**MOUNT OWEN CONTINUED
OPERATIONS PROJECT**

Response to Submissions

REPORT A:
NSW Agency and Community Submissions

June 2015

FIGURE 4.1

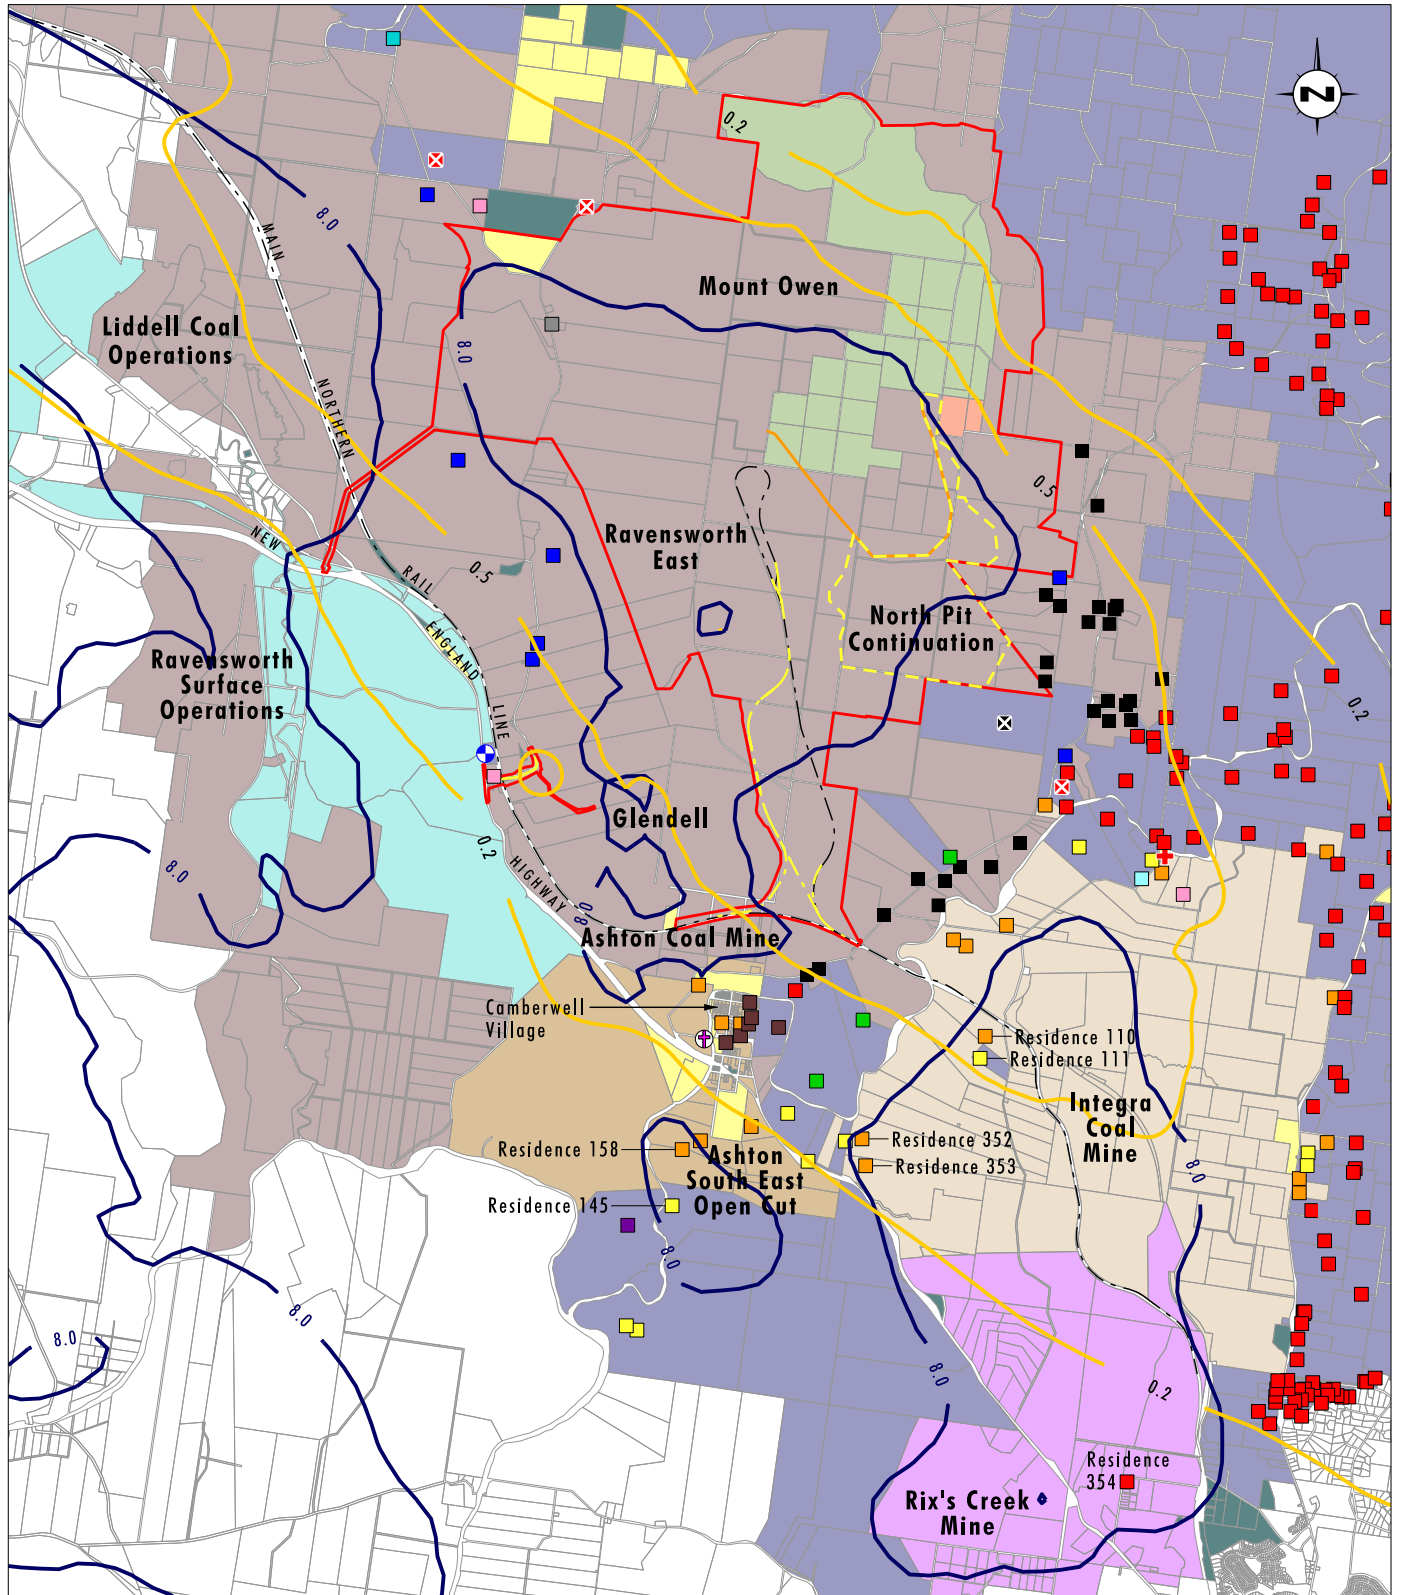
Following a review of the approach to cumulative modelling (refer to discussion below and **Appendix B**), the use of existing Camberwell PM_{2.5} monitoring data for background was identified as contributing to a potentially significant over-prediction of cumulative PM_{2.5} impacts as it resulted in a double counting of emissions from mining sources. **Appendix B** of this Report details the revised approach to modelling cumulative PM_{2.5} annual average impacts. The revised approach uses background PM₁₀ levels derived from local and regional monitoring points which are less influenced by mining operations, and applies a ratio of PM_{2.5}:PM₁₀ determined by analysing measurements from co-located PM_{2.5} and PM₁₀ monitors from the EPA monitoring network. This method has been used in previous assessments in the area. This PM_{2.5} background is then added to the modelled impacts from the Project and non-mining sources.

Figure 4.1 shows the results of the revised calculations of predicted annual average PM_{2.5} concentrations for Year 1 (the worst case for cumulative PM_{2.5} assessment). The blue contour represents the predicted annual average PM_{2.5} concentrations from all sources (including the Project and all other mining and non-mining sources); all areas within the contour are predicted to have annual average levels of PM_{2.5} exceeding 8 µg/m³ (the annual average ARS) based on conservative assumptions.

The yellow contours in **Figure 4.1** illustrate the predicted Project contribution to annual average PM_{2.5} levels and **Table 4.1** sets out the properties where there is a predicted exceedance of the PM_{2.5} annual average ARS (8 µg/m³) and the Project's contribution to impacts at these locations. The data in **Table 4.1** updates the PM_{2.5} predictions provided in Tables E1 and E2 of the AQIA for these properties.

It can be seen from **Figure 4.1** and **Table 4.1** that concentrations at the levels of predicted impact from the Project alone (<1 µg/m³ at all private residences in all modelled years) are well within the margin of error of any conventional instrumentation used to measure PM_{2.5} and hence, any change in PM_{2.5} levels due to the Project is likely to be undetectable.

FIGURE 4.2

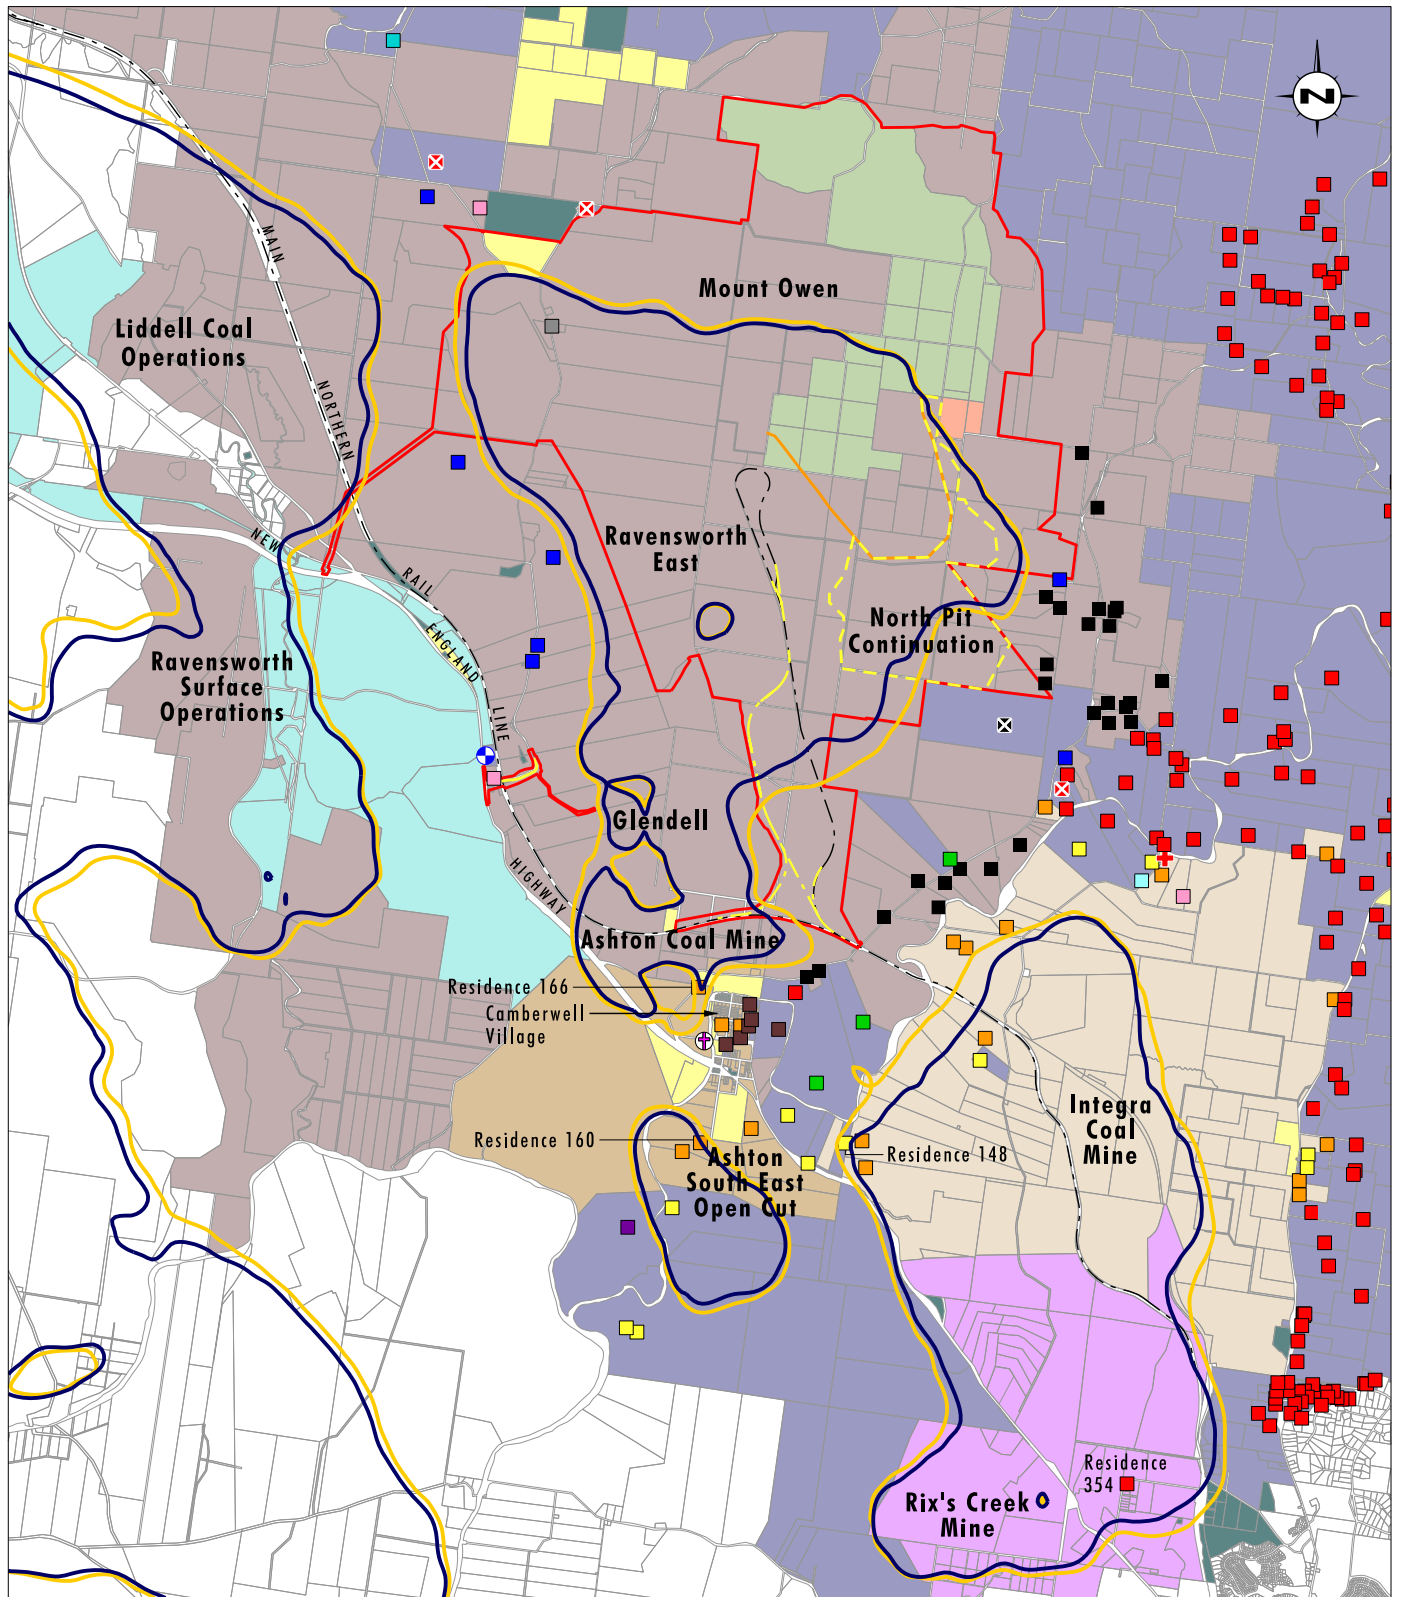
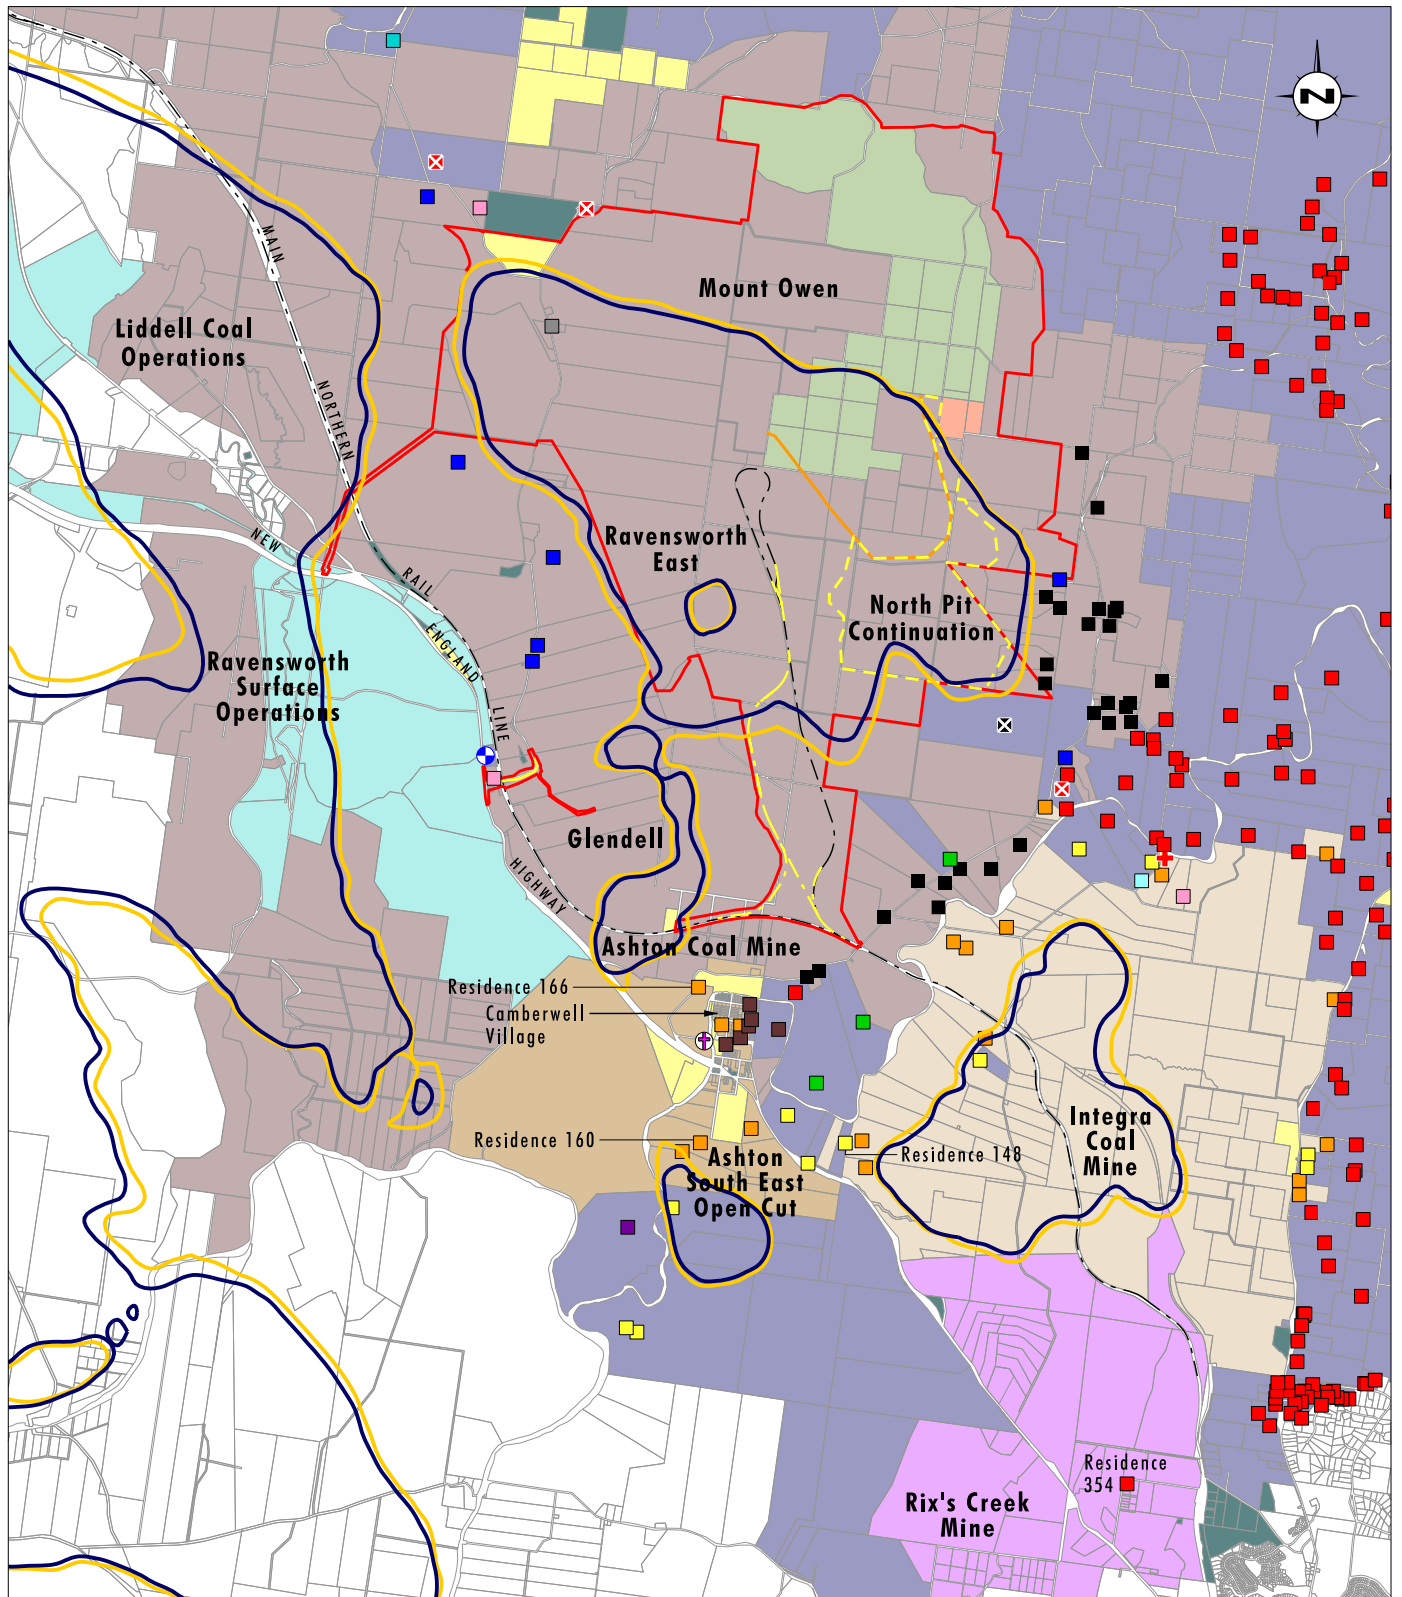
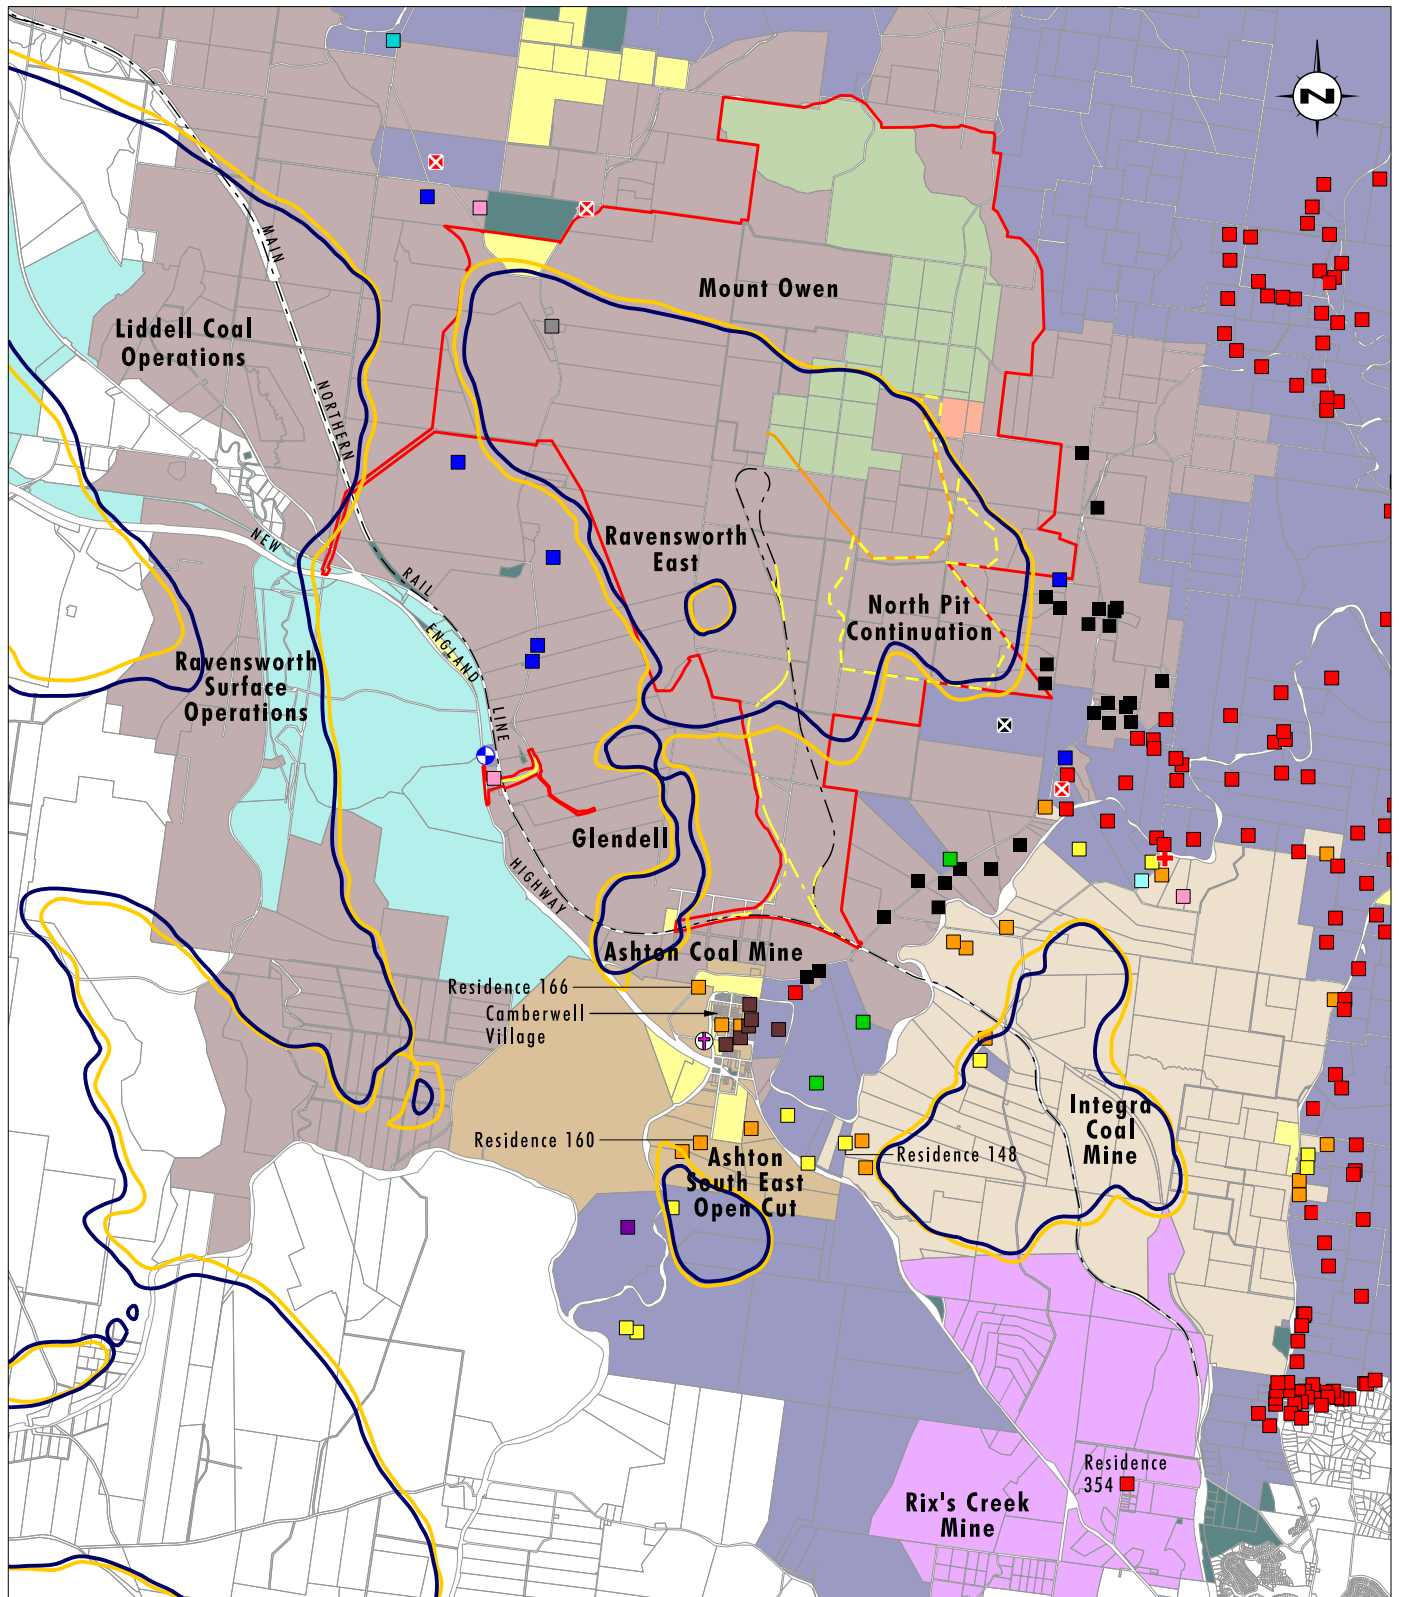
The adopted annual average PM₁₀ background value appears low (13.2 µg/m³), noting that this PM₁₀ value is less than 50% of the adopted PM_{2.5} background value in a region where ambient air quality is likely to be predominantly influenced by major PM₁₀ emission sources. Further, the dataset used to devise the annual average PM₁₀ background has been analysed in a manner that reduces the influence of extreme values without sufficient justification.

The background PM₁₀ levels referred to are only used in the modelling of cumulative annual average impacts. Cumulative annual average concentrations are determined by adding together modelled impacts from the Project, modelled impacts from other mining sources and background levels. The use of background data that had minimal influence from mining sources, yet was indicative of other background contributions from other sources in the region, was therefore necessary to avoid a double counting of mining related emissions in the assessment.

The median value of 13.2 µg/m³ has been used in the assessment. As discussed in **Appendix B**, the annual mean for the same period is 14.9 µg/m³. **Figures 4.2, 4.3 and 4.4** show the extent of the annual average PM₁₀ criterion contour, using both the median (dark blue line) and the mean (yellow line). In the worst case year (Year 1), three additional residences are predicted to exceed the 30 µg/m³ criteria if the mean, rather than the median, is used. Two of these, R166 and R160, are already mine owned. The third, R148, is privately owned but has existing acquisition rights under the Integra project approval due to predicted noise impacts.
